Access Compliance Report Public Rights-of-Way (Curb Ramps)

Main Street: HEWES_AVE Cross Street: FAIRHAVEN_AVE Location: SW

ADA ID: RPRK211006181538 Ramp Type: Type 7 - Directional 2 Initial Pass/Fail: Fail Overall Compliance: No Severity Score: 2

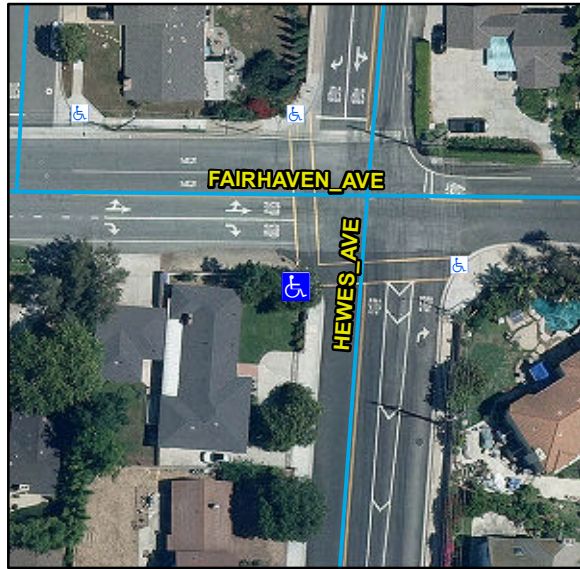
Compliance	Description	Data	Compliance	Description	Data
N/A	Ramp Length (in)	150	N/A	Flare Type LT	
Yes	Ramp Width (in)	50			N/A
Yes	Ramp Run Slope (%)	7.1	N/A	Flare Slope LT (%)	N/A
No	Ramp Cross Slope (%)	4.8	N/A	Flare Traversable LT	N/A
N/A	Grade Break	N/A	N/A	Flare Type RT	
N/A	Grade Break Slope (%)	N/A			N/A
N/A	Grade Break Cross Slope (%)	N/A	N/A	Flare Slope RT (%)	N/A
	Addl Para Ramp Left?	No	N/A	Flare Traversable RT	N/A
	Addl Para Ramp Right?	No	N/A	DWS Provided	N/A
N/A	Landing Present	N/A	N/A	DWS Contrast	N/A
N/A	Landing Length (in)	N/A	N/A	DWS Length (in)	N/A
N/A	Landing Width (in)	N/A	N/A	DWS Full Width	N/A
N/A	Landing Run Slope (%)	N/A		DWS Offset Type	N/A
N/A	Landing Cross Slope (%)	N/A	N/A	DWS Left Offset (in)	N/A
N/A	Landing Movement Obstructed?	N/A	N/A	DWS Right Offset (in)	N/A
	Landing Movement Type	N/A			
N/A	Landing Shared	N/A			
N/A	Marked Crosswalk 1	Yes	N/A	Clear Space	Yes
	Crossing 1 Direction	E	N/A	Clear Space To Crosswalk (in)	48

Remove & Replace Curb Ramp With Two New Directional Ramps or Equivalent.
